Memorandum

From: Meredith Jones, P.E. V.P., Eden & Associates

RE: Variances/Exceptions for Glade Spring Rezoning Application

STREET B DRIVE AISLE EXHIBIT

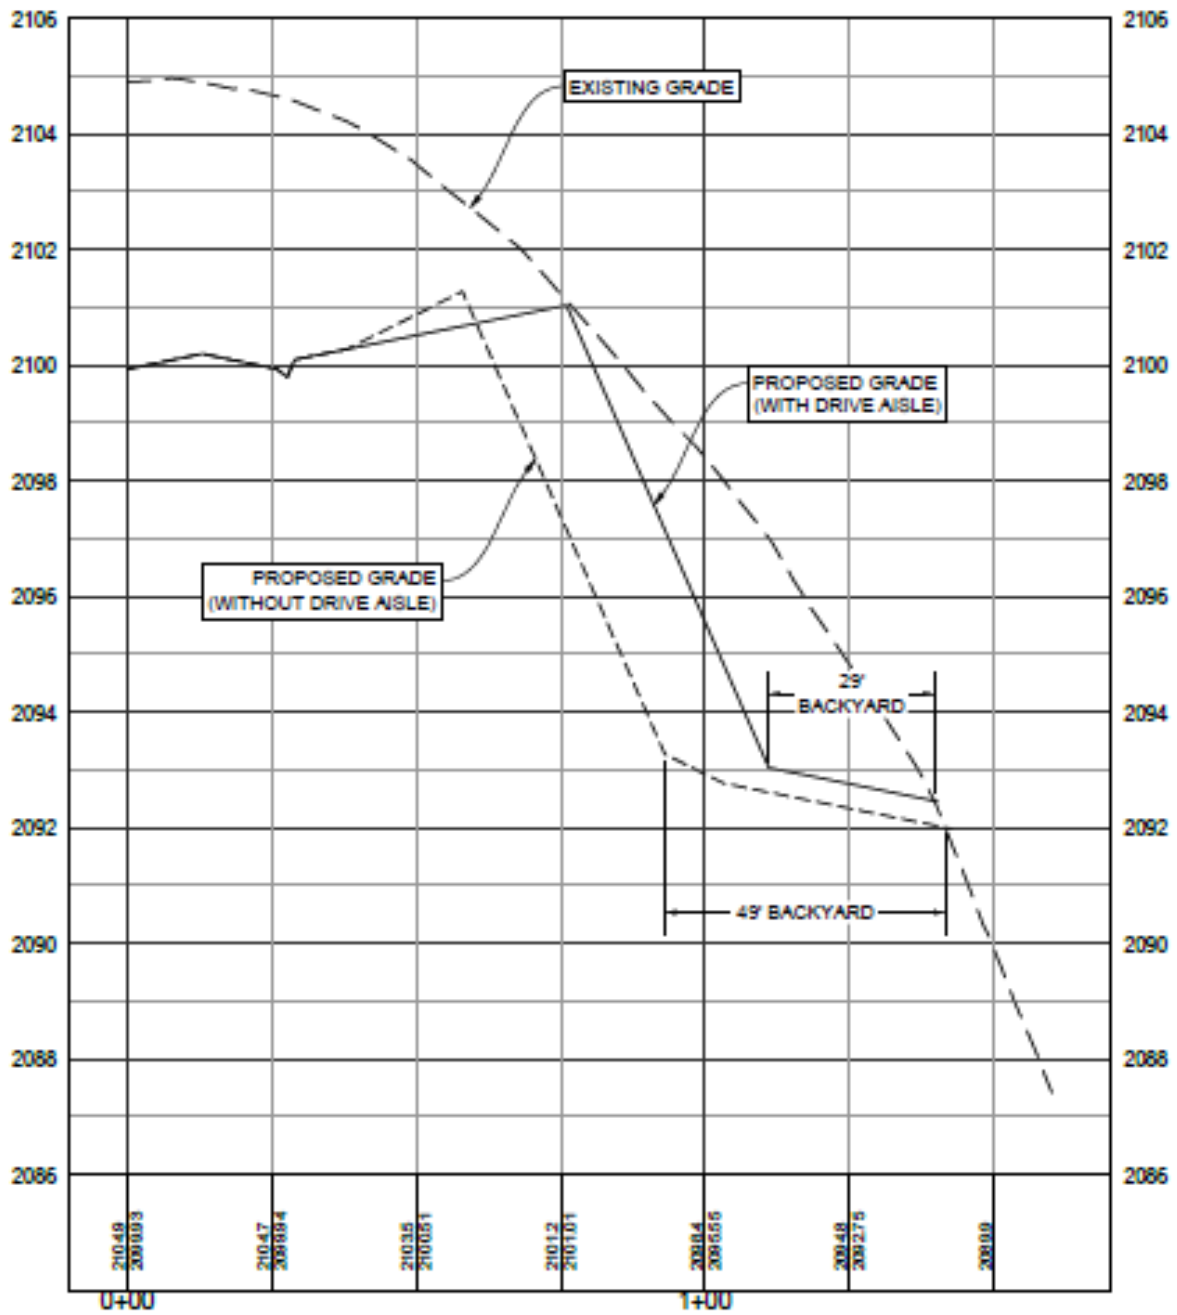
14. **Special Exception to 5202 (c)** all parking spaces shall be located such that maneuvering in or backing into a public street shall not be permitted. Single-unit dwellings and two-family dwellings on a local street are exempt, but not townhouses.

- a. Applicant requests that driveways to townhomes that contain parking spaces be permitted to back out into the public street.
 - b. There does not exist room on the site to accommodate “turn-arounds” or separate drive-aisles in order to meet the ordinance requirements. The applicant evaluated examples and those are included in the exhibits below. The result of this analysis shows that additional cut and fill areas are prohibitive with the lot geometries shown on the plan. Furthermore, in comparing the preferred alternative (separation of driveways so that no more than two contiguous driveways exist from #11), with the drive aisle alternative, there is little difference in pedestrian conflict areas. Both provide adequate breaks for the pedestrian and for the view of the driver backing out. Driveway entrances still exist in either scenario; though certainly the driver is facing forward on a drive aisle scenario. The preferred scenario preserves less impervious surface, less cost, and accommodates the current lot configurations better. As is seen on the exhibit, lot depths significantly increase in a drive-aisle scenario and would restrict which lots could accommodate townhomes in an already restrictive elevation setting. A cross section example is shown on the low side of the road, which makes it apparent how much more grading would be needed, adding cost, but also reducing usable backyard space deepening lots, and reducing open space. Furthermore, the goal of the development is to create affordable units and that requires keeping homeowner’s association fees low. A drive aisle would have to be contained in a privately maintained easement, across private lots, whereby the HOA would have to maintain these areas separately from the unit owners. This is not a preferred option for the HOA, and to expect private owners to maintain their portion of the drive aisle is an unrealistic expectation as well as expensive.

#14 continued:
